UNITED STATES
NUCLEAR REGULATORY COMMISSION
WASHINGTON, D. C. 20555

AMENDMENT TO FACILITY OPERATING LICENSE

Amendment No. 36
License No. NPF-30

SAFETY EVALUATION BY THE OFFICE OF NUCLEAR REACTOR REGULATION
RELATED TO AMENDMENT NO. 36 TO FACILITY OPERATING LICENSE NO. NPF-30

Figure 3.4-2

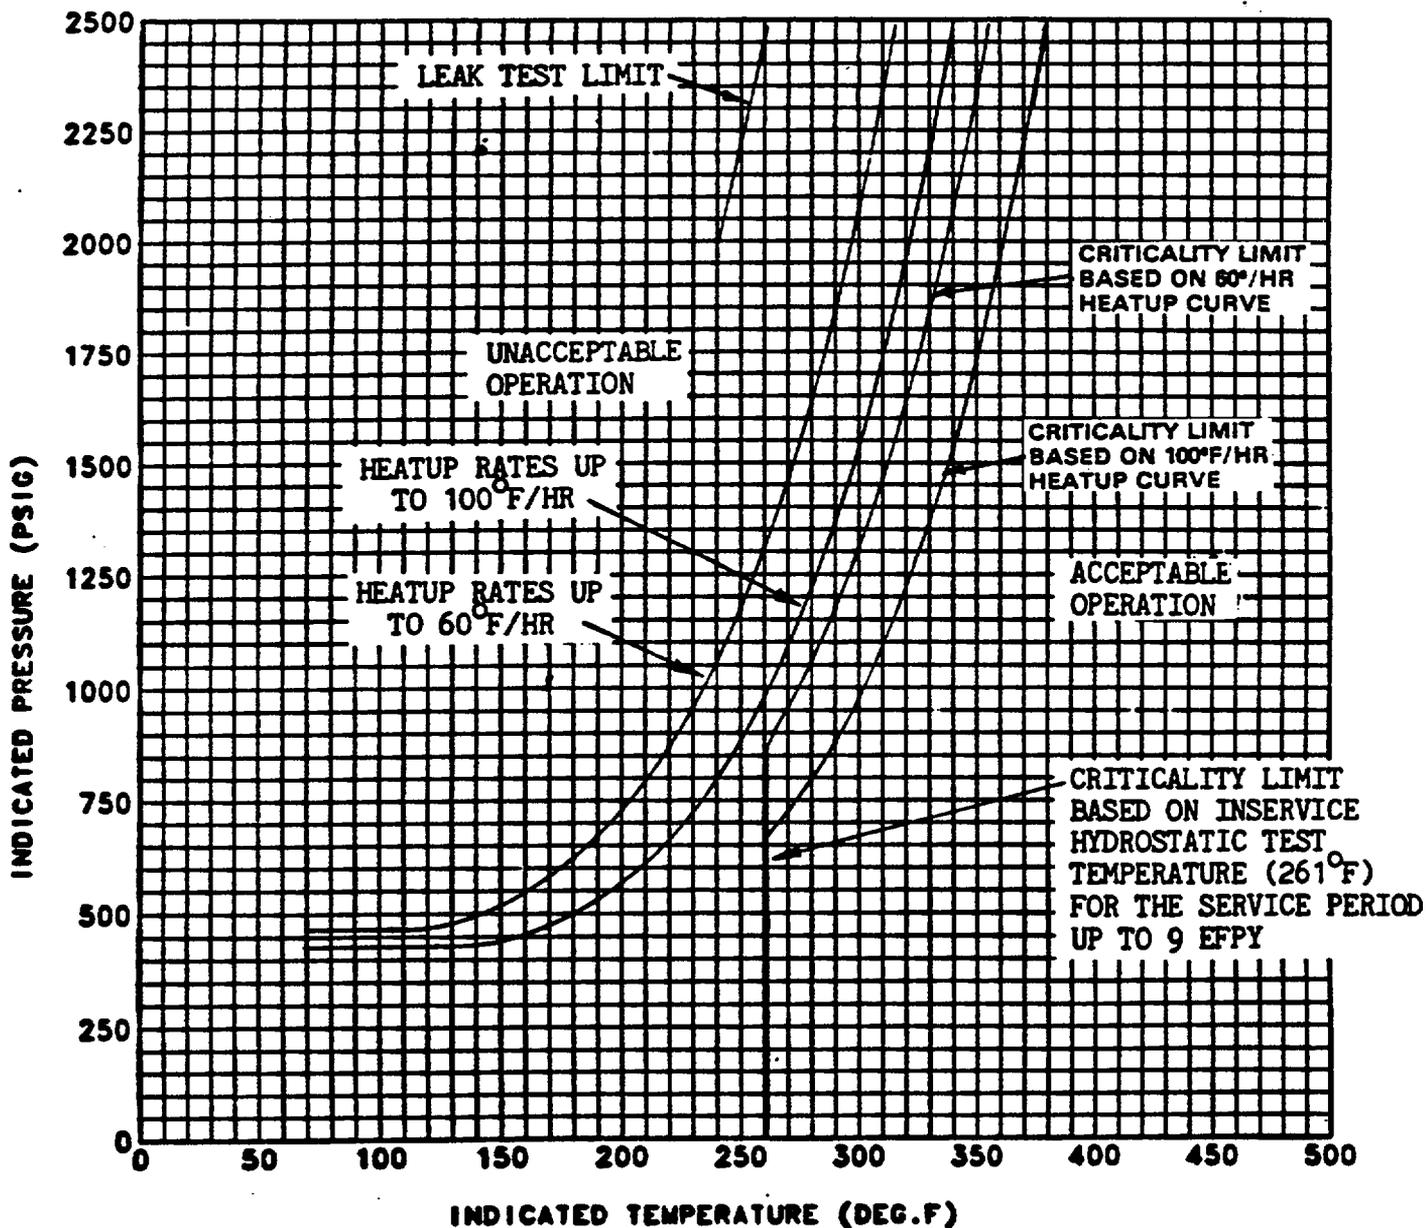
The amendment revises the plant heatup and cooldown curves, revises the maximum allowable power operated relief valve (PORV) setpoint curve, and revises the reactor vessel surveillance capsule removal schedule.

By letter dated July 31, 1987, as supplemented by letter dated February 19, 1988, the Union Electric Company requested revision of the pressure-temperature limits in Callaway Plant Technical Specifications Section 3/4.4.9. The proposed limits will incorporate the updated pressure vs. temperature curves through 9 effective full power years (EFPY) to account for irradiation effects on the reactor vessel material. The proposed limits were based on the Westinghouse analysis (WCAP-11374, Rev. 1) of irradiation data taken from surveillance specimen Capsule U. The limits provide maximum permissible pressure at temperature for three reactor operations--system hydrostratic and leakage test, heatup or cooldown, and core critical condition. The pressure-temperature limits have to satisfy the requirements in Appendix G of 10 CFR Part 50. The licensee also requested revision of the maximum allowed power-operated relief valve (PORV) curve for the cold over-pressure mitigation system, and a revision to the surveillance capsule withdrawal schedule based on the neutron fluence data taken from Capsule U.

Capsule U experienced an average fast neutron fluence of 3.27×10^{18} n/cm². The lower shell plate material, R2708-1, has the highest initial RT_{NDT}, 50°F, the highest percentage of copper, 0.07%, and the highest percentage of nickel 0.59%. Using Regulatory Guide 1.99, Rev. 2, the adjusted RT_{NDT} of the plate was calculated to be 122°F and 112.5°F at the 1/4 T and 3/4 T vessel-wall-thickness locations, respectively. These results show that the predicted transition temperature shift based on Regulatory Guide 1.99, Rev. 2 is higher than the shift obtained directly from the surveillance capsule. Therefore, it is conservative and acceptable using the results of the Regulatory Guide to develop the pressure-temperature curves.

The staff has used the method of calculating pressure-temperature limits in USNRC Standard Review Plan 5.3.2, NUREG-0800, to evaluate the proposed pressure-temperature limits. The amount of neutron irradiation damage was calculated based on Regulatory Guide 1.99, Rev. 2. The staff concludes that the proposed pressure-temperature limits meet the requirements of 10 CFR Part 50, Appendix G for 9 EFPY and may be incorporated into the Callaway Plant's Technical Specification. Also, the revised surveillance capsule withdrawal schedule satisfies the requirements of 10 CFR Part 50, Appendix H, and is acceptable.

CURVES APPLICABLE FOR HEATUP RATES UP TO 100°F/HR FOR THE SERVICE PERIOD UP TO 9 EFPY AND CONTAINS MARGINS OF 10°F AND 60 PSIG FOR POSSIBLE INSTRUMENT ERRORS

REACTOR COOLANT SYSTEM HEATUP LIMITATIONS
 APPLICABLE FOR THE FIRST 9 EFPY.
 UPDATED TO 3565 Mwt.

FIGURE 3.4-4

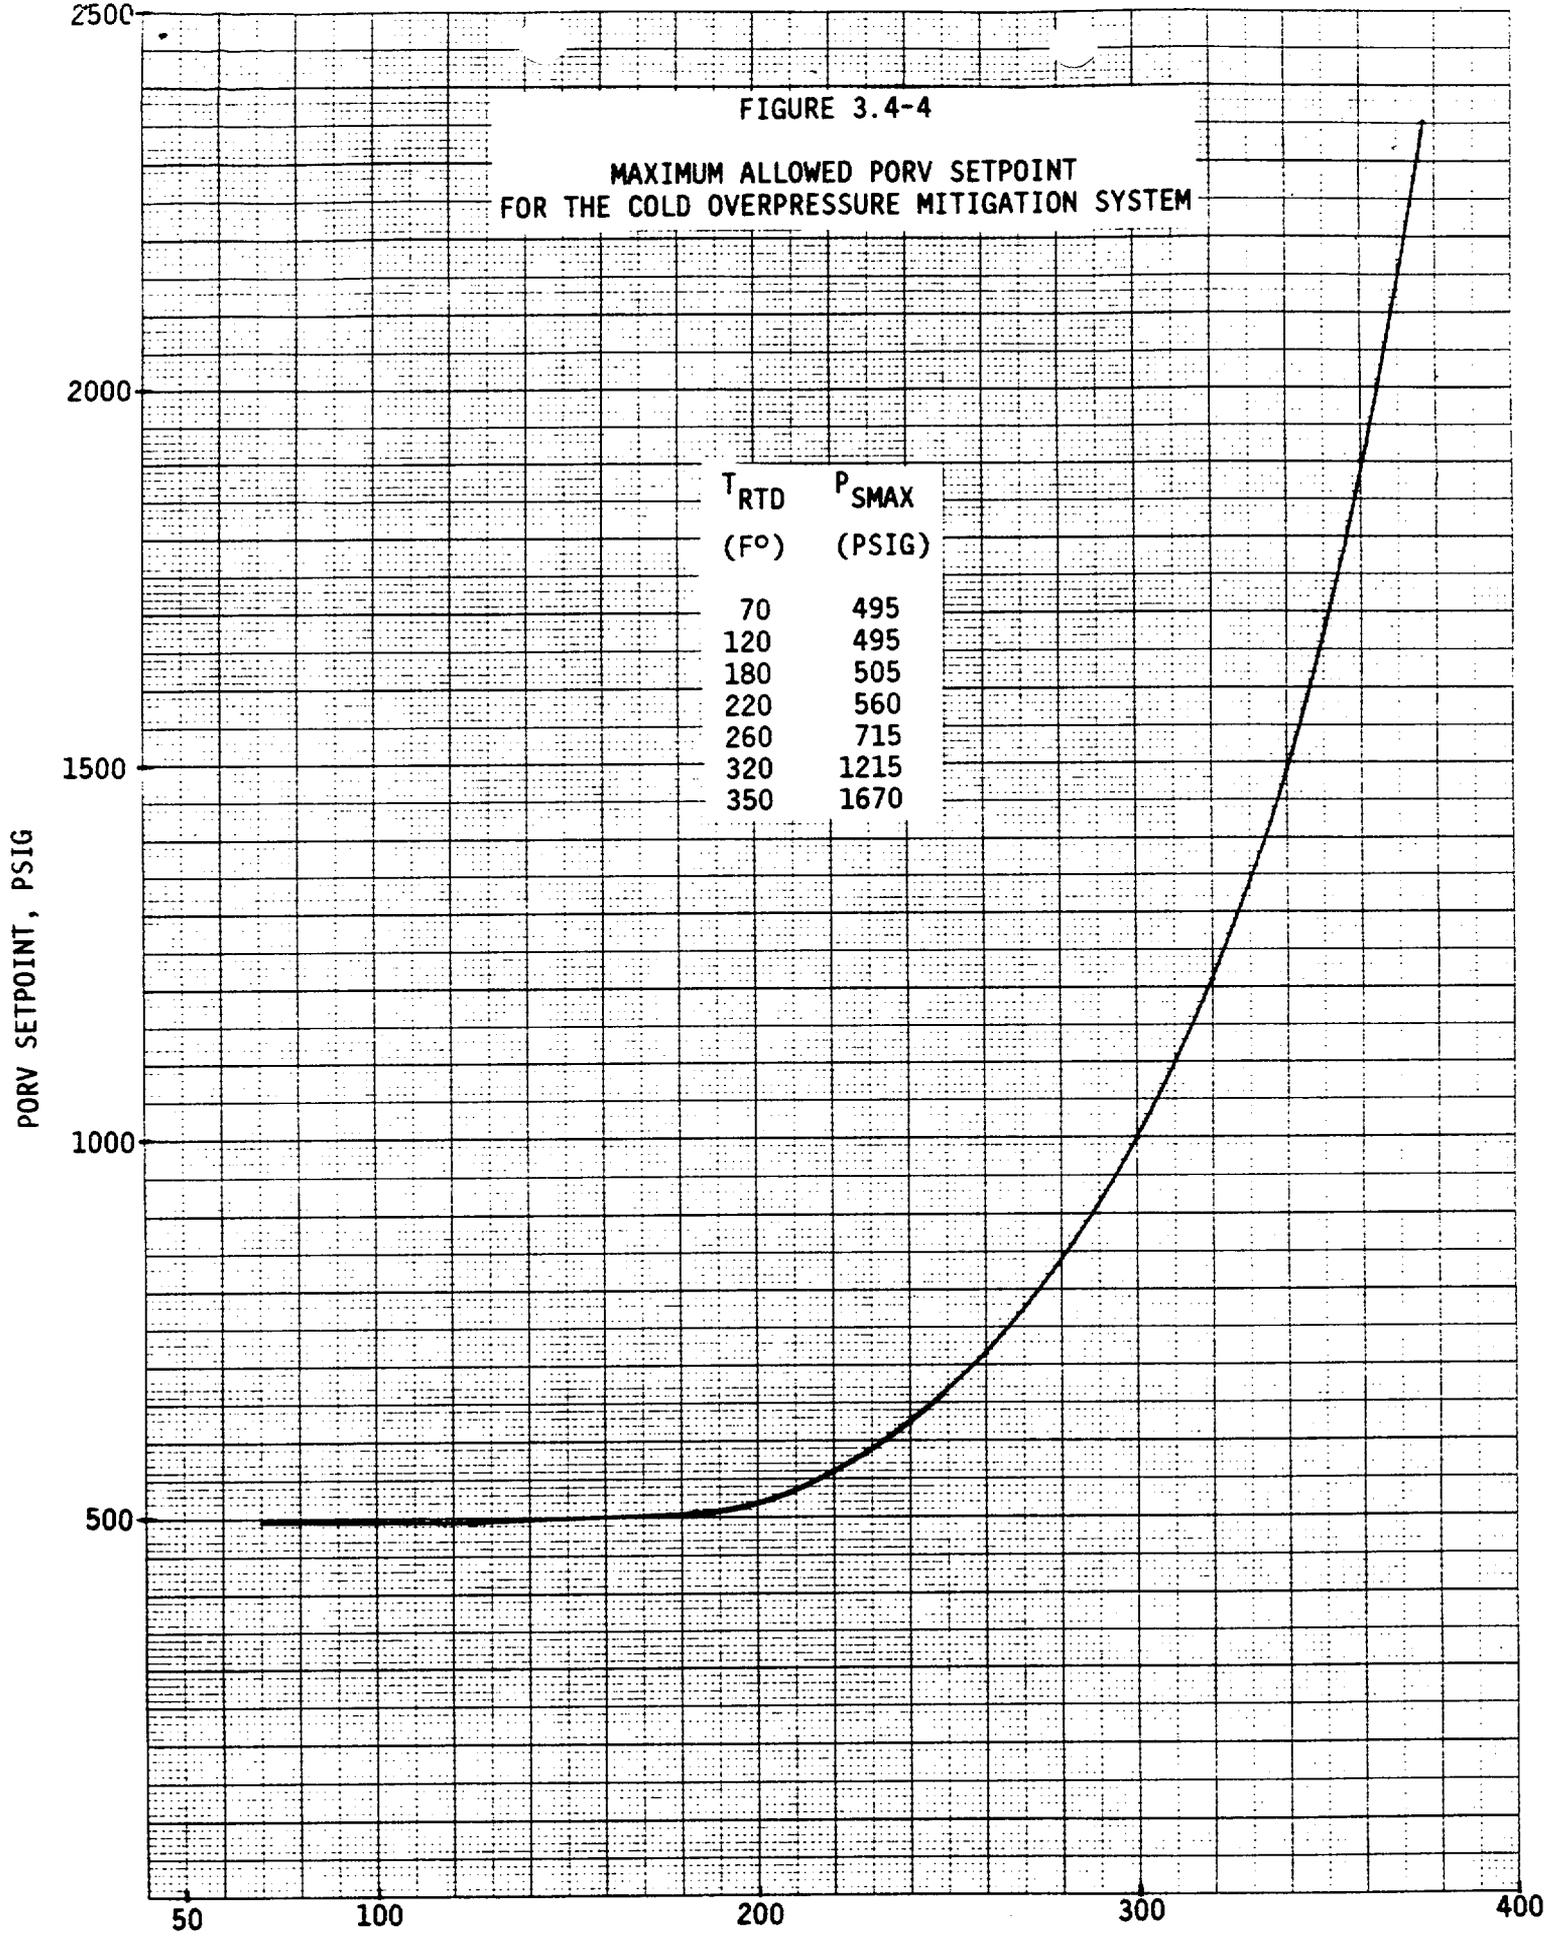
At the staff's request, the licensee provided the analyses, including the limiting mass and heat addition transients analyzed, the initial conditions, major assumptions and the results of the analyses, to support the maximum allowable PORV setpoints in the revised Figure 3.4-4.

The limiting mass addition transient involves the operation of a single charge pump at the maximum flow with inadvertent isolation of letdown flow and residual heat removal system (RHRS) relief valves. The limiting heat addition transient is an inadvertent RCS coolant pump startup in one loop with a temperature asymmetry in the RCS, whereby the steam generator is at a temperature 50°F higher than the rest of the RCS. The initial conditions and major assumptions include the pressurizer being water solid to maximize the pressure surge, the failure of one PORV, and the time delay in the PORV operation. As indicated in the licensee's response dated February 19, 1988, these transients and assumptions are identical to those used in the previous analyses in the Callaway FSAR Section 5.2.2.10 except for the use of the revised Figure 3.4-4 for the PORV setpoints.

The results of analyses indicate that the peak RCS pressures for the transients analyzed fall below the nominal Appendix G pressure limits. The staff, therefore, concludes that the revised Figure 3.4-4 is also acceptable.

MAXIMUM ALLOWED PORV SETPOINT
FOR THE COLD OVERPRESSURE MITIGATION SYSTEM

T _{RTD} (F°)	P _{SMAX} (PSIG)
70	495
120	495
180	505
220	560
260	715
320	1215
350	1670
